Agenda
for
120th PCC Meeting

AGENDA FOR 120th PROTECTION COORDINATION SUB-COMMITTEE MEETING TO BE HELD ON 16.11.2022 AT 10:30 HOURS THROUGH MS TEAMS ONLINE MEETING PLATFORM

Report on the grid event in Eastern Region (पूर्वी क्षेत्र में ग्रिड घटना पर रिपोर्ट)

Figure 1: PMU snapshot of 400/220 kV Daltonganj S/s

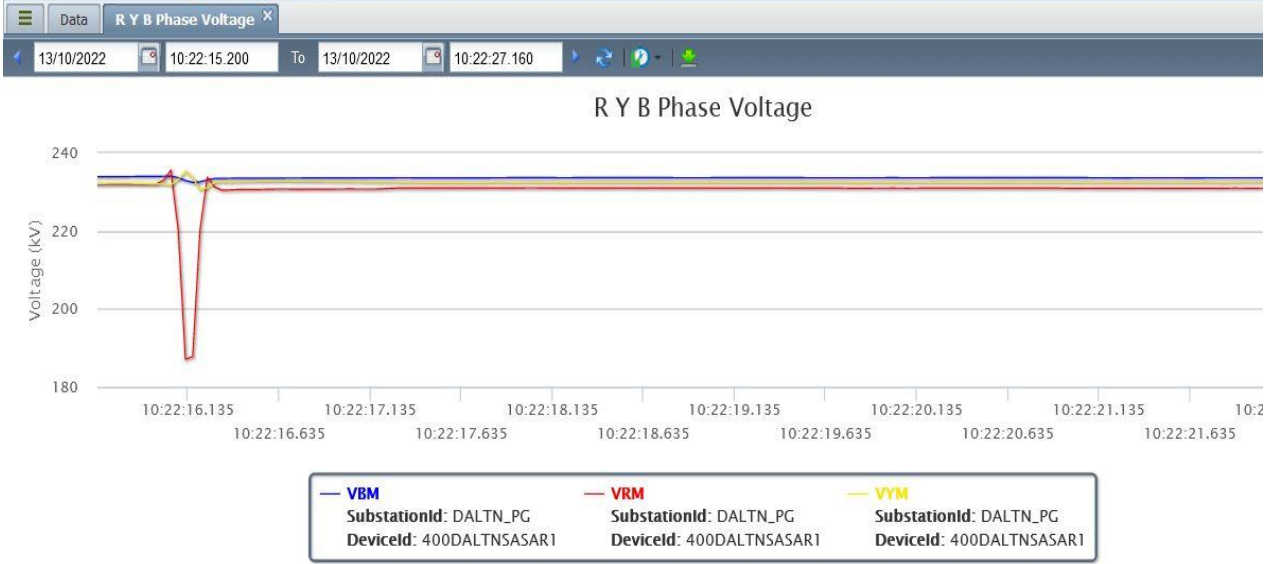
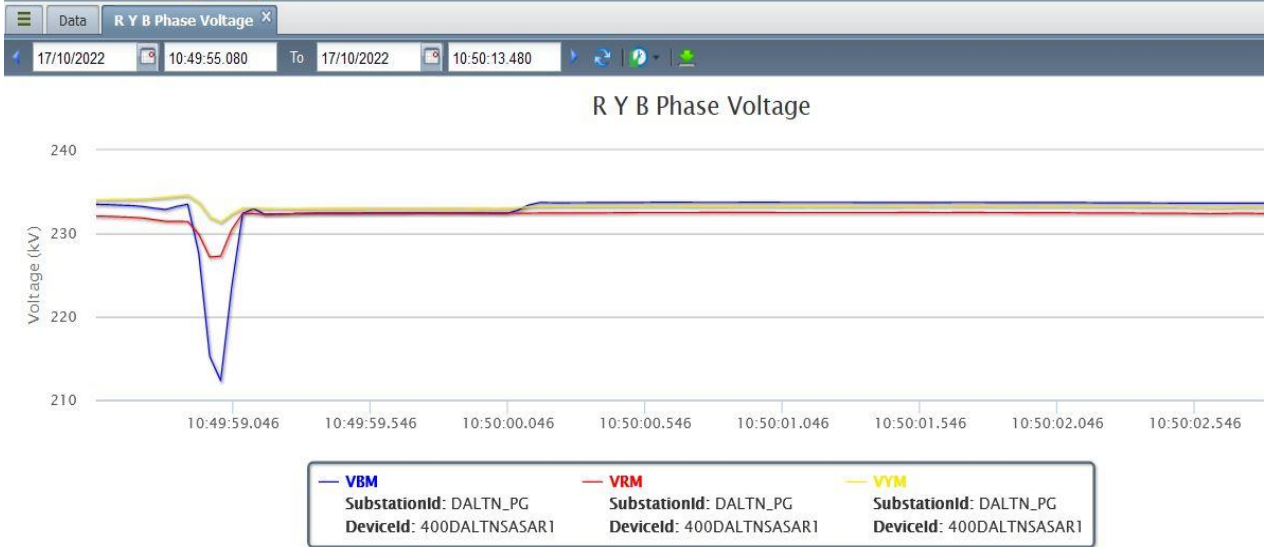
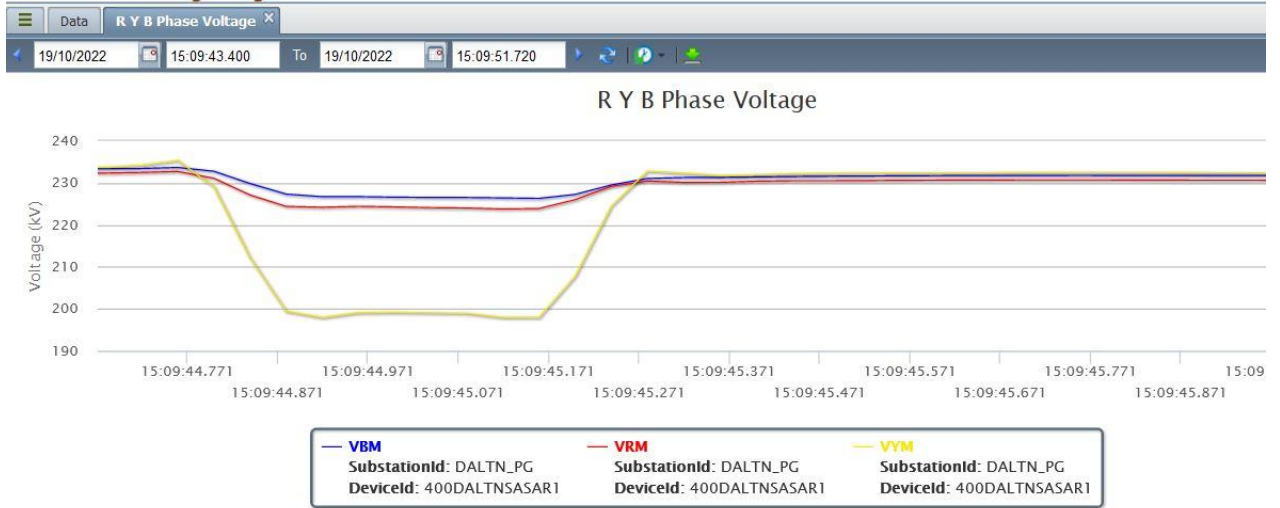
- In 1st and 2nd event, A/r was successful from Daltonganj only. Issue of Non-A/r at Chatra end has been flagged multiple times. JUSNL may update.
- In 3rd event, fault was cleared from Daltonganj in Zone-2 time, suggesting failure of carrier protection. JUSNL may explain.
- Both LILO portions of 220 kV Daltonganj-Chatra-2 at Latehar has not been charged yet, hence affecting reliability of power supply at Chatra. JUSNL to explain the reason for delay in charging of the line.
